Access Compliance Report

Public Rights-of-Way

(Curb Ramps)

Intersection ID: 29121	Main Street: APPLE_GLEN_LN	Cross Street: HIGHLAND_PARK_DR	Location: NE
ADA ID: 59110BFA83CC	Ramp Type: Perp	Initial Pass/Fail: Fail	Overall Compliance: No
Severity Score: 12.5			
Codes/Mitigation Info/Possible Solution		Field Measurements/Component Compliance

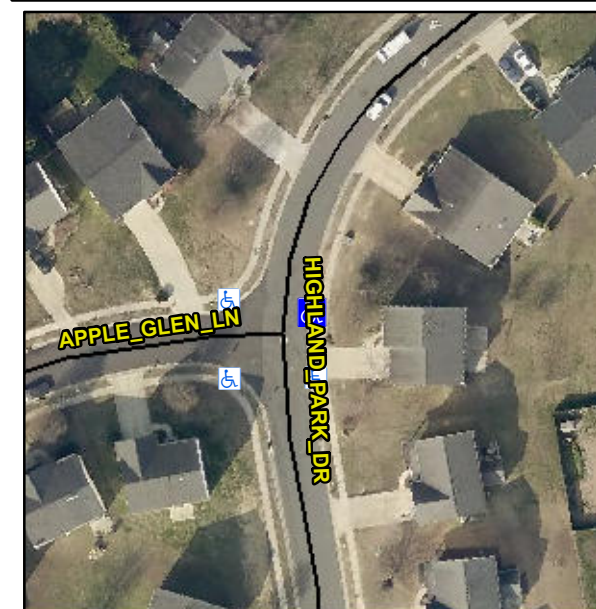
R304.5.3

Compliance	Description	Data	Compliance	Description	Data
N/A	Ramp Length (in)	48.0	Yes	Ramp Slope (%)	6.0
Yes	Ramp Width (in)	48.0	No	Ramp XSlope (%)	5.9
N/A	Flare Type LT	N/A	N/A	Flare Type RT	N/A
N/A	Flare Slope LT (%)	N/A	N/A	Flare Slope RT (%)	N/A
N/A	Flare Traversable LT?	N/A	N/A	Flare Traversable RT?	N/A
N/A	Landing Length (in)	N/A	N/A	DWS Provided?	N/A
N/A	Landing Width (in)	N/A	N/A	DWS Contrast?	N/A
N/A	Landing Slope (%)	N/A	N/A	DWS Length (in)	N/A
N/A	Landing X Slope (%)	N/A	N/A	DWS Full Width?	N/A
N/A	Landing Curb? (Y/N)	N/A	N/A	DWS Offset (in)	N/A
N/A	Shared Landing?	N/A			
N/A	Gutter Ponding?	N/A	N/A	Gutter Slope (%)	N/A
N/A	Gutter Lip Ht (in)	N/A	N/A	Gutter X Slope (%)	N/A
N/A	Painted X Walk1?	No	N/A	Painted X Walk2?	N/A
	X Walk 1 Direction	To W		X Walk 2 Direction	N/A
N/A	X Walk 1 Width (in)	N/A	N/A	X Walk 2 Width (in)	N/A
	X Walk 1 Slope (%)	2.4		X Walk 2 Slope (%)	N/A
	X Walk 1 X Slope (%)	5.6		X Walk 2 X Slope (%)	N/A

Remove & Replace Entire Ramp.
